Staff Report

Infill Housing Design Review Committee

File Number: 6-F-21-IH

Location: 808 Hiawassee Ave. **Parcel ID** 81 C B 023

Back Elevation

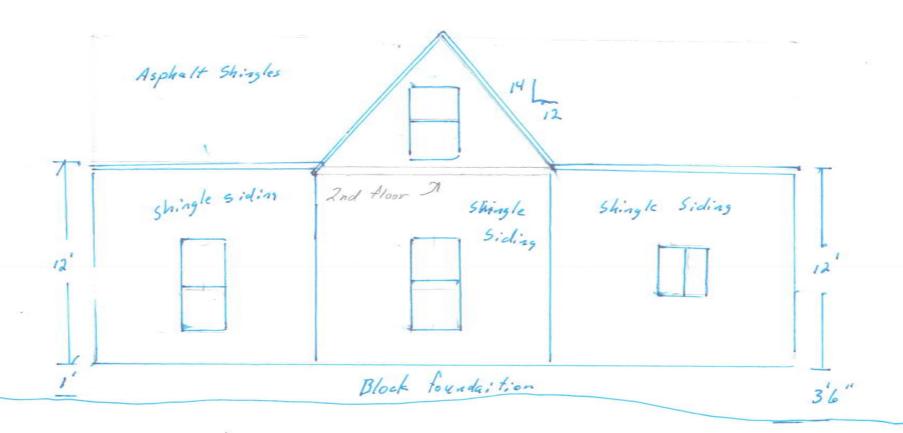
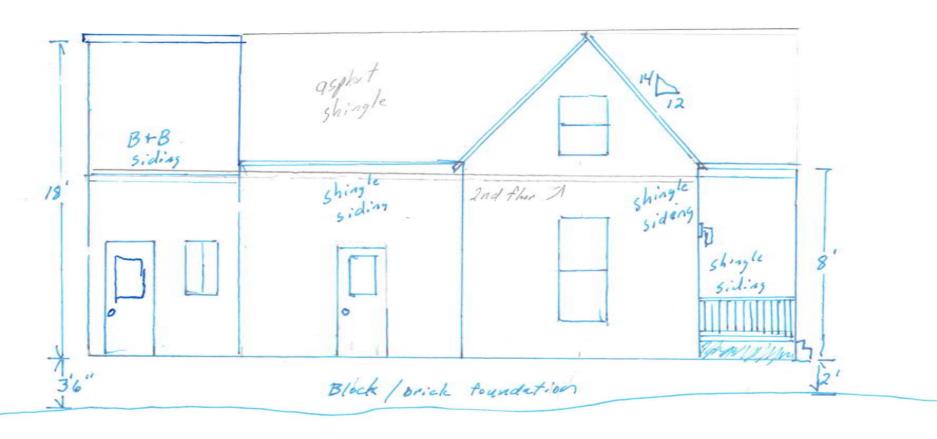
- 4. Guidelines note that additions' rooflines should complement the original house. The flat-roof addition and its connection with the original hipped roofline does not complement the original house.

- 6. Final specifications of rear corner access stoops and decks should be submitted to staff for approval.

1) Specifications for two rear corner access stoops or decks be submitted to staff for approval.
